Re: Engineering Services
2665 Ash Ave.
Dunn, NC

Tyndall Project No.: 1701-020196

Jul
HARNETT COUNTY CENTRAL PERMITTING
APPLICATION # 1750040951
JOB NAME Rayford McCloud
DATE PLANS RECEIVED 6.3.17
SITE PLANS APPROVED Approved w/exception
APPROVED BY h3 *WJ*

SECOND & THIRD FLOOR PLAN

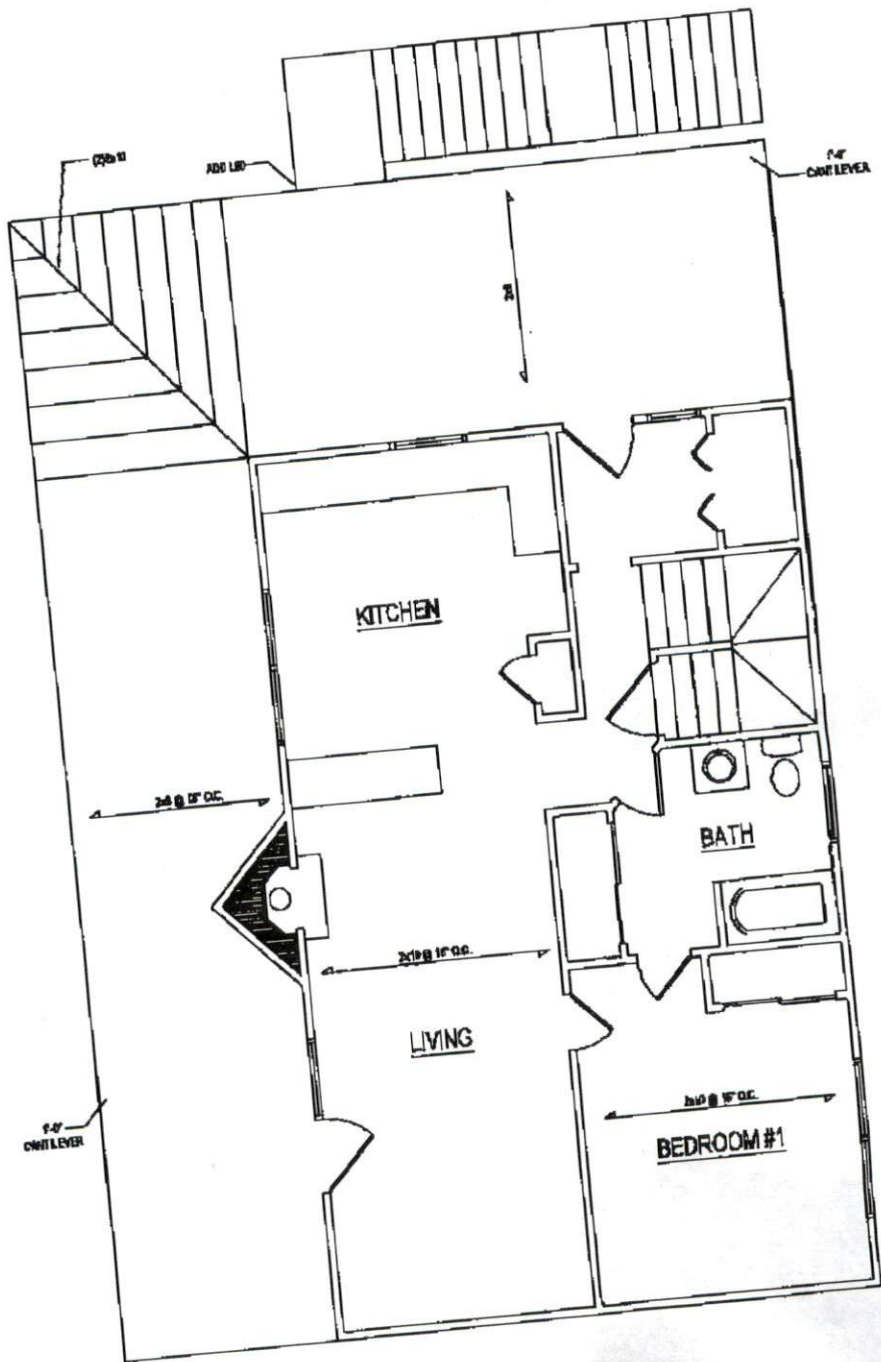
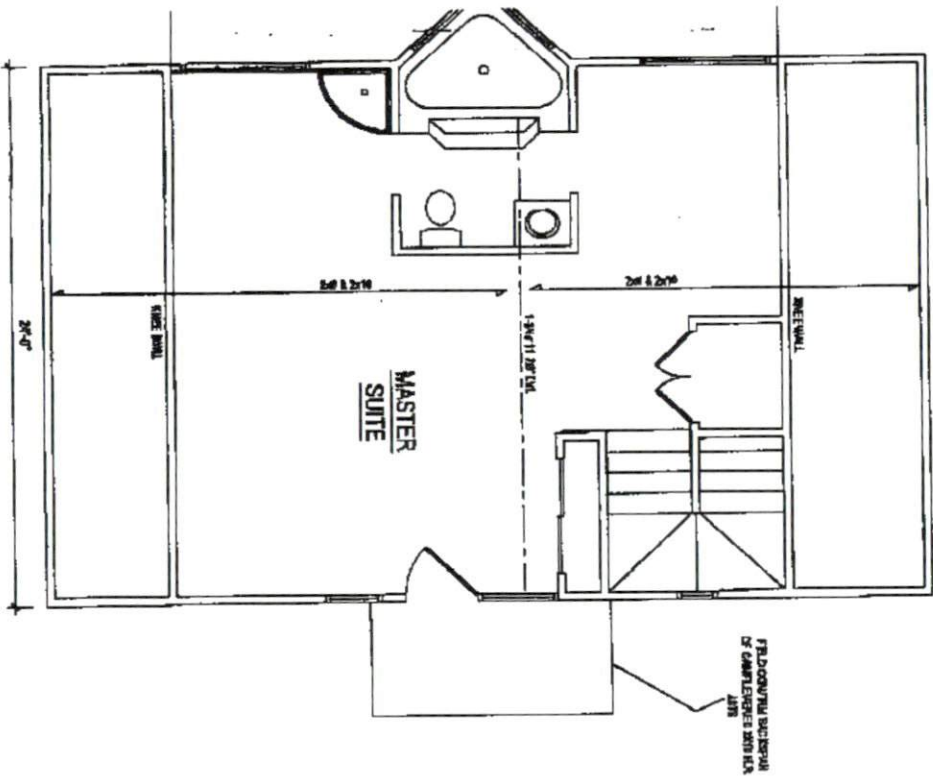
- 4) This condition occurs at multiple points within the stair corridors. TE&D recommends rebuilding the staircases as necessary to provide minimum head height clearances (6'-8"). Note: Installing a spiral staircase may be an option that could be considered for this item.
